BYRON SHIRE COUNCIL

**COUNCIL ASSESSMENT REPORT – MODIFICATION
APPLICATION**
NORTHERN REGIONAL PLANNING PANEL

PANEL REFERENCE & DA NUMBER	PPSNTH-409 – DA10.2022.371.4
PROPOSAL	Modification to residential flat building including increase in building height within R3 Medium Density Residential and 7(F2) Urban Coastal Land zones and increase in size of rooftop areas across all buildings.
ADDRESS	<p>Lot 2 DP 582519 29 Shirley St Byron Bay. The address of the subject site at the time of the original development consent was 29 Shirley Street, 2 & 4 Milton Street Byron Bay, comprising the following lots:</p> <p>Lot 8 Section 52 DP758207 Lot 9 Section 52 DP758207 Lot 2 DP582819 Lot 7 DP841611 Lot 12 DP1138310 Lot 1 DP582819 Lot 1 DP780935 Lot 8 DP841611 Lot 9 DP841611</p>
APPLICANT	Urbis Pty Ltd
OWNER	29 Shirley Street Pty Ltd
MOD LODGEMENT DATE	14 February 2025
ORIGINAL DA DETERMINATION DATE	16 October 2023
APPLICATION TYPE	Modification Application under Section 4.55(2)
REGIONALLY SIGNIFICANT CRITERIA	Clause 2.18(1), Schedule 6 of <i>State Environmental Planning Policy (Planning Systems) 2021</i> : General development over \$30 million

Figure 3: Proposed Shirley St Elevation (R3 zone)

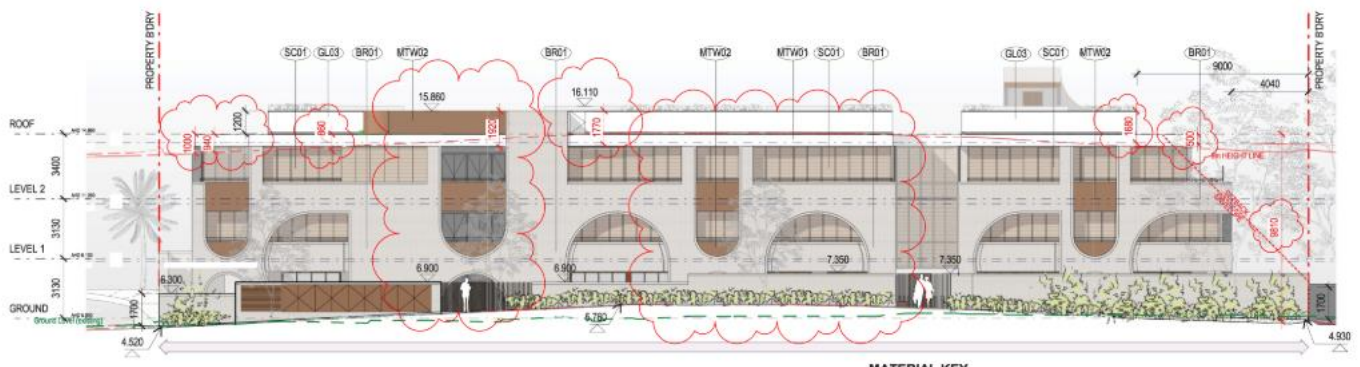
The previous modification application DA10.2022.371.2 sought a similar increase in height and was not approved. The floor to ceiling heights can be reduced and a minimum clear floor to ceiling height of 2.7m can be achieved on all floors within the approved height limit. **The thickness of the basement slab at approximately 1.5m appears excessive and no reason has been given for why such a thick slab is required.** Options exist for this slab to be reduced to allow for the lowering of the ground floor level. The approved height is consistent with the existing medium density character of Shirley St and was a key reason for the granting of consent to the original application.

Figure 7: Proposed height R3 zone

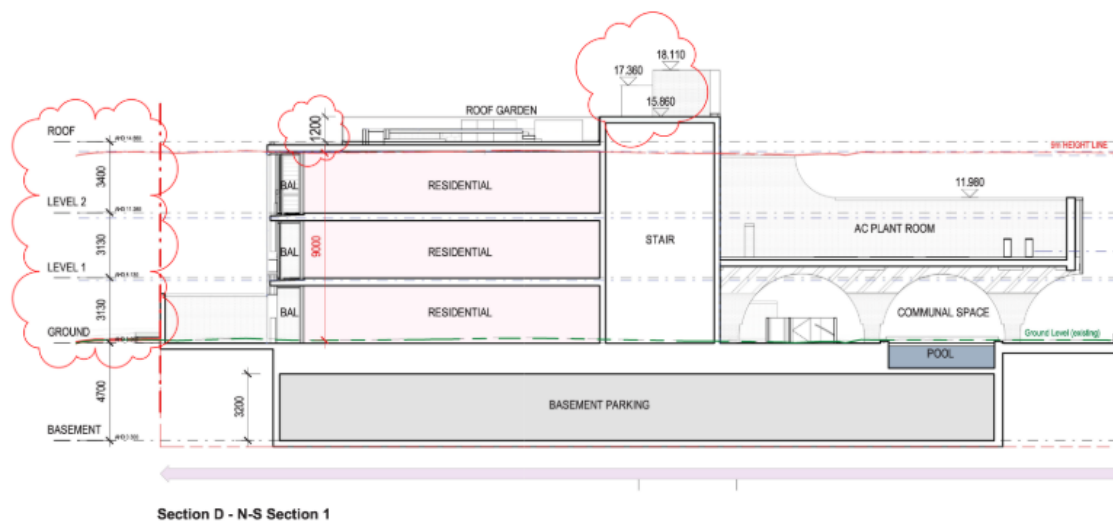
The lift overrun for unit 201 was also proposed in the previous modification DA10.2022.371.2 and was not approved. The proposed lift overrun results in a height exceedance of 4.05m. The addition of a lift overrun to the rooftop terrace of unit 201 results in excessive height and visual impacts notwithstanding it has approved access via stairs. A lift to a rooftop terrace is not a requirement of the BCA, BDCP 2014 Chapter B13 Access

The applicant's argument that the height exceedance is required to provide compliant pool fences for the roof top pools does not override or negate the requirement for the development to comply with the legislated height controls. The floor to ceiling heights can be reduced as well as the thickness of the basement slab in order to comply with height controls. Compliance with the approved maximum height was a key reason for the granting of consent to the rooftop terraces and pools.
